FIELD EVALUATION OF STEEL FABRICATED HANDPUMPS FOR THE USAID/DOMINICAN REPUBLIC HEALTH SECTOR II PROJECT

WASH FIELD REPORT NO. 139

FEBRUARY 1985

Prepared for:
USAID Mission to the Dominican Republic
Request Memorandum No.106

Illustration 5. The handle pivot assembly consists of a steel pin with a snug fit through two bushings on the handle. This fit is necessary to ensure that the pin may be removed to service the below-ground parts of the pump.

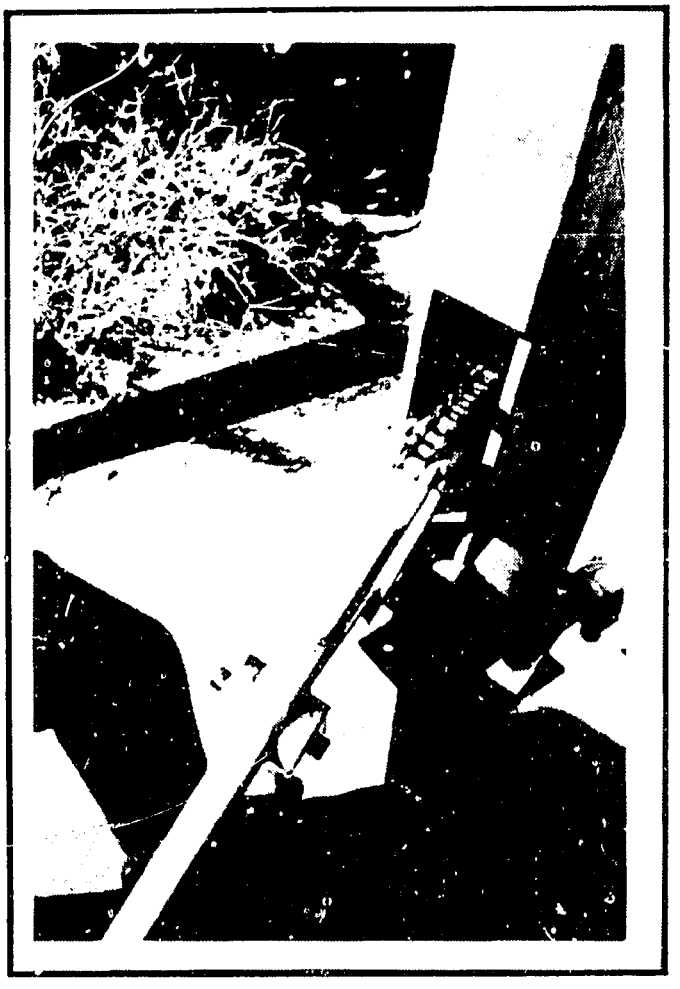
The most critical element in the design of the "Steel" handpump is the relationship among the ball bearings, the main shaft, and the handle. In the model observed in the field, there is a snug fit of the shaft through the handle bushing and at the ball bearings (see Illustrations 5 and 6). Once water enters the bearings, the shaft begins to turn in the races, as well as in the handle bushing. When this turning occurs, the system becomes a steel-on-steel system instead of the ball bearing system it was designed to be. Because it is almost impossible to lubricate the friction points, excessive wear quickly sets in (see Illustration 7).

Illustration 6. Smooth operation of the handle pivot assembly depends on the movement of the ball bearings. Once water enters the bearings the shaft tends to turn in the inner rate and/or in the handle bushings, thereby causing excessive wear to the shaft.

Illustration 8. Note grout used to level the platform to accommodate the flat plate of the base. Cracks in this grout allow water to enter the well as the casing is flush with the platform.

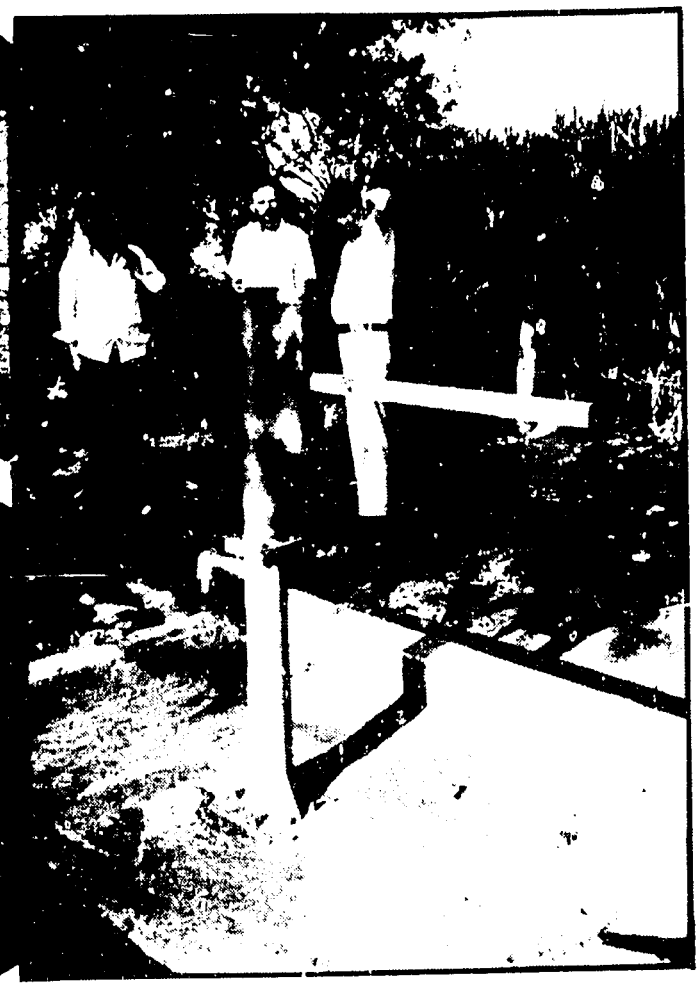
All of the handpumps observed in the field revealed a common design problem that does not allow the base to make a positive, unbreakable sanitary seal. The current design depends on the bond between the base plate and the top of the platform. (The top of the well casing is level with the top of the platform.) Cracks in the grout used to level the base were observed to allow small amounts of water to enter the water. Over the years, this condition can be expected to get worse (see Illustrations 8 and 9).

Illustration 9. Note that platform grouting will cause water to pond at pump base and raise the potential of infiltration into the well through cracks in the grout.

Illustration 15. Field maintenance crews have few tools. Thus, they tend to make extensive use of lockgrips and pliers. As a result, many bolts have been either chewed or stripped.

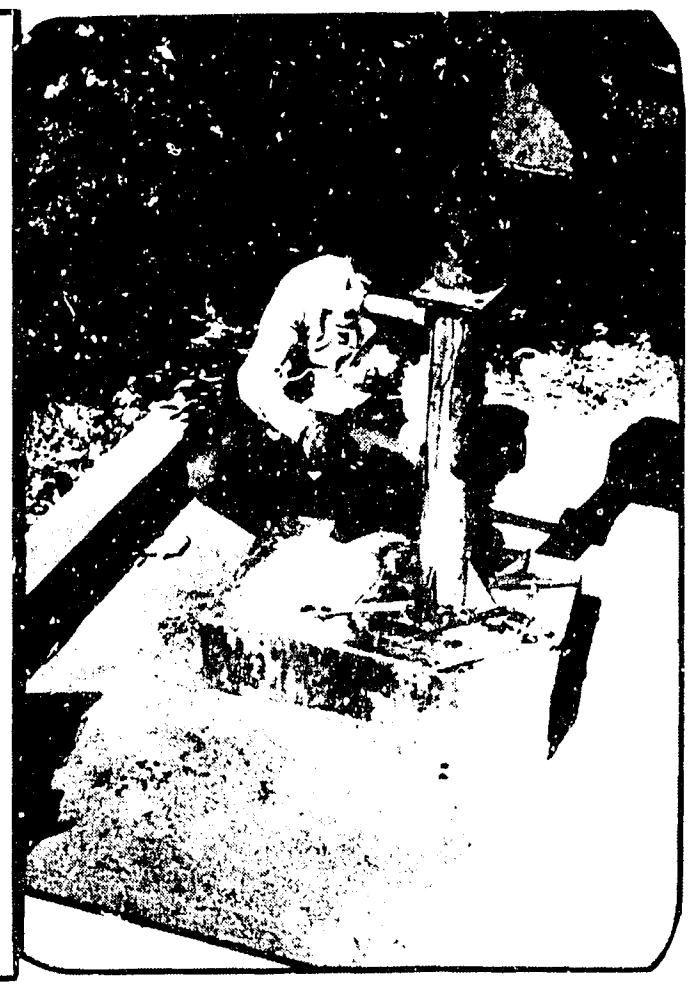
Illustration 15 shows the diversity of tools that the field crews are currently using during pump repair visits. WASH feels that the numerous tools should be standardized to a few simple key ones. Such standardization would help to reduce the broken bolts and the tendency of field personnel to use pliers and lockgrips which tend to destroy bolts quickly.

Figure 4. Details of Coupling Between Chain and Drop Rod

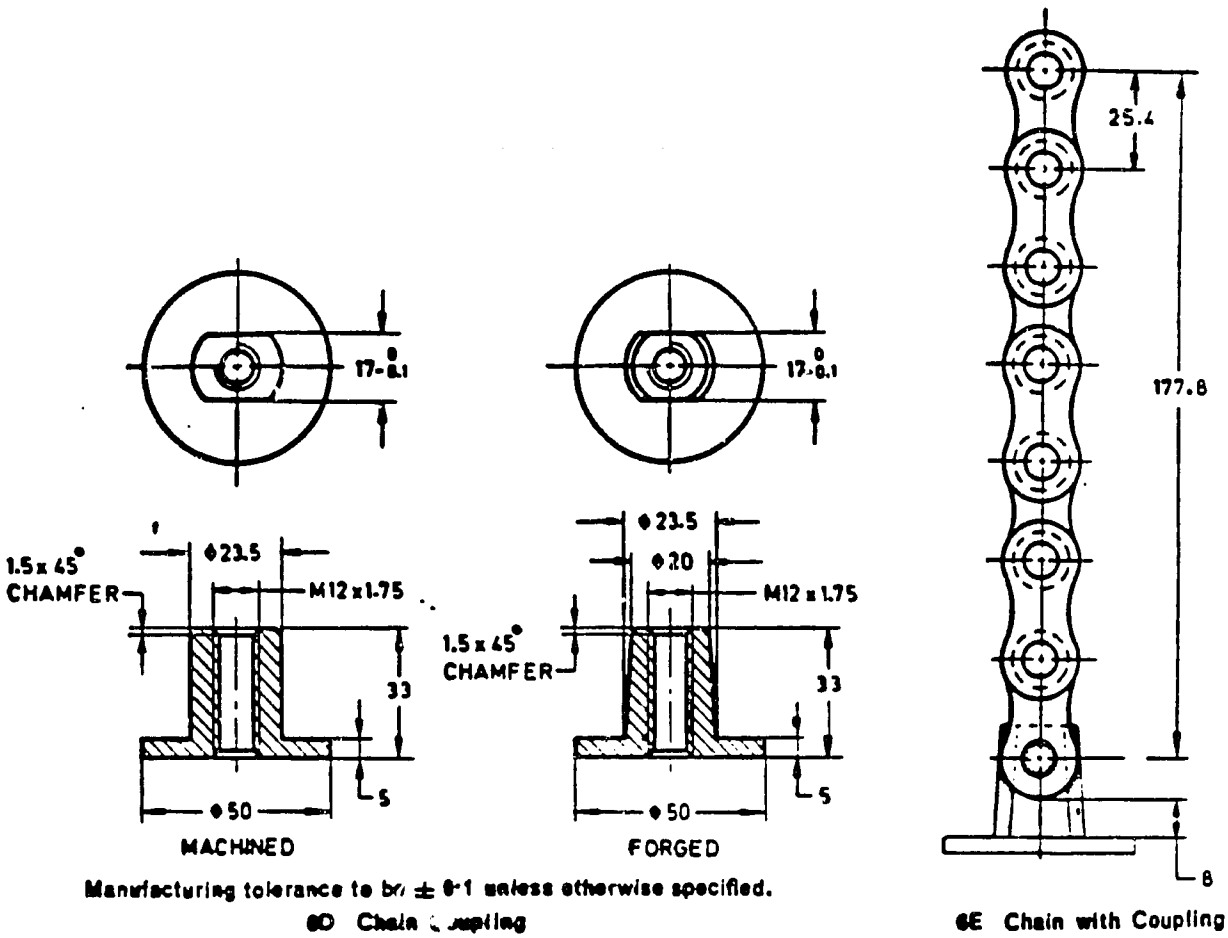
The roller chain selected by the Georgia Institute of Technology (motor cycle No. 428 or Industrial RC40) appears to be too light. In addition, the scheme to connect the chain to the quadrant has been modified to use standard chain connecting links. The light chain and the modified system seem reasonably satisfactory at shallow SWL depths (that is, 7 feet to 20 feet). At depths greater than 30 feet, however, it is expected that early failure could be common. The one pump set at 160 feet (Hania) required a heavier duty chain to be fitted after constant failure of the original.

The design should be standardized on a 3/4-inch Pitch Industrial Chain H060. Once again, it may be advisable to follow a proven method as developed for the India MK II where the chain is anchored to the handle by a high tensile bolt and self-locking nut, having a diameter to fit the chain link hole without the bush. In this design, the chain is welded to the chain coupling versus using a bottom pin as in the pump currently being tested (see Item 6D of Figure 4). While this is not usual practice, it has given good results in the India MK IIs used in India. A self locking bolt may be considered if welding becomes too difficult. (The 3/4-inch industrial chain would use a 5/16-inch diameter bolt; see Figure 4). The 3/4-inch chain is readily available on the local market. The design should also be changed to allow the chain to run on its roller, rather than on the link, as is done currently.
